WARNING OF POTENTIAL SAFETY HAZARD
RE: W J FURSE AND FURSE STAIRLIFTS, MODELS 103 AND 185 -
MANUFACTURED BETWEEN 1982 AND DECEMBER 1988

**TECHNICAL BULLETIN FOR W J FURSE AND FURSE STAIRLIFTS,
MODELS 103 AND 185 STAIRLIFT MANUFACTURED BETWEEN 1982 AND 1988**

TITLE	GEARBOX SHAFT AND BEARING ASSEMBLY
SCALE	1:2.5
DATE	28.6.82

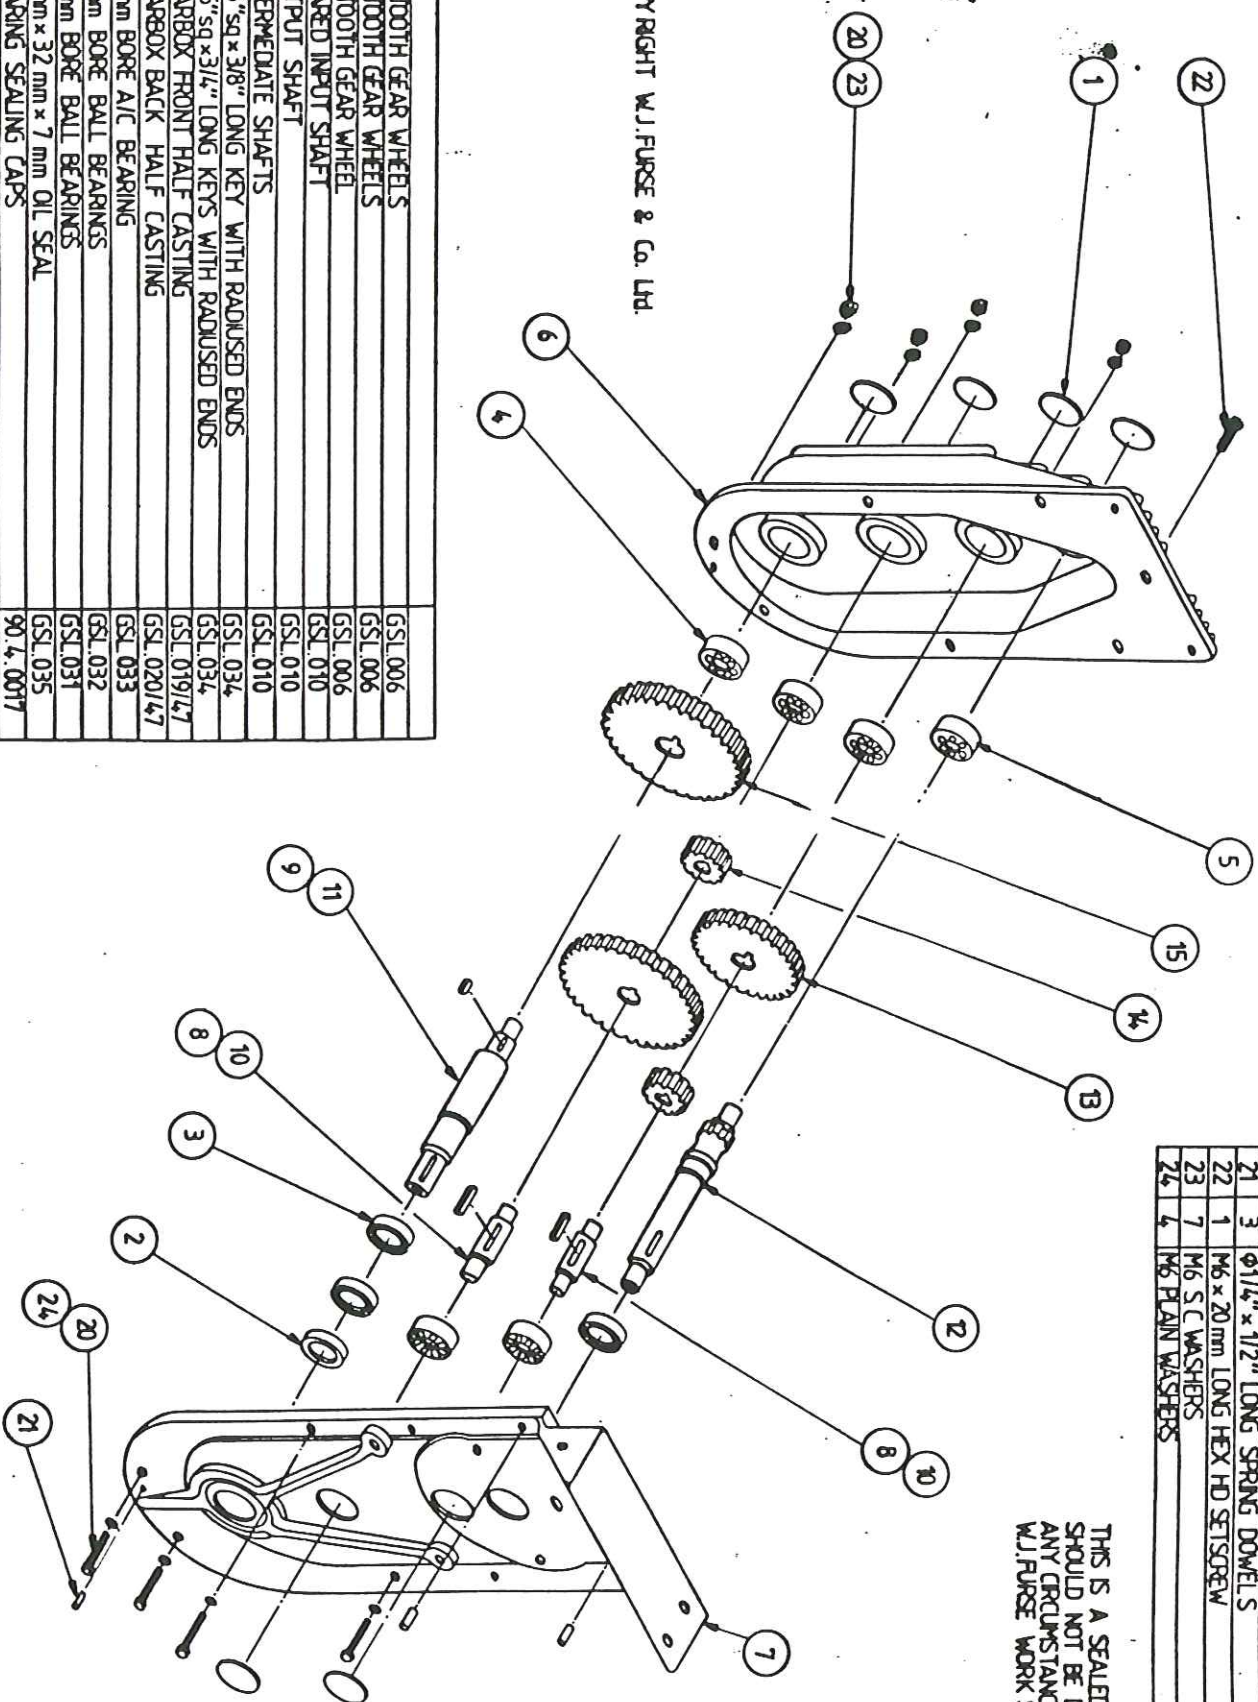
During the period of manufacture some 5,300 units were produced with a common gearbox design. We have 15 failures of the gearbox output shaft reported to us, 14 being sheared keys the other being a sheared shaft.

We attach a technical bulletin, technical drawing (the relevant components are parts numbered 9 and 11) and procedure for removal of the gearbox.

The components that have given cause for concern are the gearbox final drive shaft and the square key locking the final drive pinion to the shaft, numbered 9 and 11 on the enclosed diagram.

Indications of pending failure are minimal but in some circumstances an increase in the noise levels has been noted, and/or the presence of excessive backlash at the drive sprocket.

The reported failures occurred when the units moved from rest, at the lower position, which is the point of maximum load on the shaft.

The shaft and key have been marked on the enclosed drawing and you will see that the only way to inspect the components is to dismantle the gearbox.

Inspection of the Key and the Keyway is one of a visual nature but inspection of the shaft in a similar fashion will not reveal a possible failure. To determine the integrity of the shaft, crack detection equipment is required.

A more cost effective action is one of removing the gearbox and sending to ourselves for dismantling, inspection and, where required, fitting of replacement output shaft and keys. Alternatively, Gimson Stairlifts can supply a service exchange gearbox or visit site and fit a re-built unit on your behalf.
